R22 SERVICE LETTER SL-87

R44 SERVICE LETTER SL-73

SUBJECT: Main and Tail Gearbox Oil

FIGURE 1

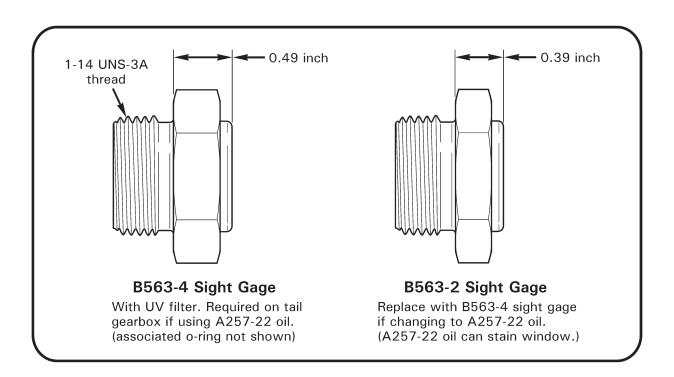
- All R22 & R44 gearboxes (including new) may use A257-2 (traditional, blue) oil
 if more convenient or desired. Drain and flush per Maintenance Manual (MM) if
 converting from A257-22 oil.
- 2. Tail gearboxes are eligible for A257-22 oil provided a B563-4 sight gage is installed (refer to Figure 1); not all tail gearboxes can be retrofitted with the B563-4 sight gage (due to thread differences).
- 3. A006 R22 main gearboxes with A146-1 Revision Q & subsequent pinion are eligible for A257-22 oil. A146-1 pinion data plate is adjacent A006 gearbox data plate.
- 4. C006 R44 main gearboxes with C146-2 Revision Q & subsequent pinion are eligible for A257-22 oil. C146-2 pinion data plate is adjacent C006 gearbox data plate.
